County of Fairfax, Virginia
Planning Commission Meeting
January 28, 2026
Planning Commission Action

2232-2025-SP-00003 - LINCOLN LEWIS VANNOY ODOR CONTROL FACILITY PROJECT
(Springfield District)

PUBLIC HEARING FOR PLANNING DETERMINATION

Application Number:	**2232-2025-SP-00003**
Applicant:	Fairfax County Department of Public Works and Environmental Services
Proposed Use:	Lincoln Lewis Vannoy Odor Control Facility
Supervisor District:	Springfield
Subject Property Tax Map ID:	66-2 ((1)) 4B1
Subject Property Address:	5426 Willow Springs School Road, Fairfax, VA 22032
Area of Subject Property:	5.19 acres
Application Accepted:	March 13, 2025
Recommendation:	In accordance with Va. Code Sec. 15.2-2232, as amended, staff recommends that the Planning Commission find that the proposal by the Department of Public Works and Environmental Services to replace and modify an existing odor control facility, at, 5426 Willow Springs School Road, Fairfax, VA, **is substantially in accord** with provisions of the adopted Comprehensive Plan.

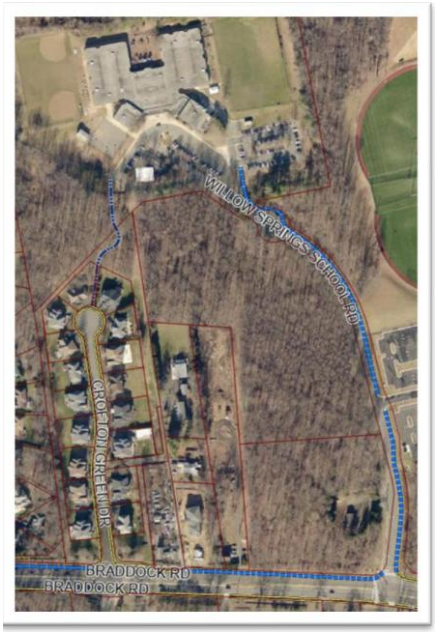
- There is no existing pedestrian facility on the west side of the school's entrance. Therefore, if a sidewalk was extended to the school site, students would have to cross the vehicle entrance to access a sidewalk.

- There is an existing pedestrian route along the east side of Willow Springs School Road as well as an alternative pedestrian route to the school facilitated by a paved trail (with easement) that connects the entrance of the school building with the sidewalk at the north end of the cul-de-sac on Crofton Green Drive, which is a public street, as shown below.

- There appears to be no significant transportation impacts from the proposed facility. With the provision of the above noted right-of-way dedications, FCDOT finds that location, character, and extent of the proposed use is in conformance with the County's transportation plan.
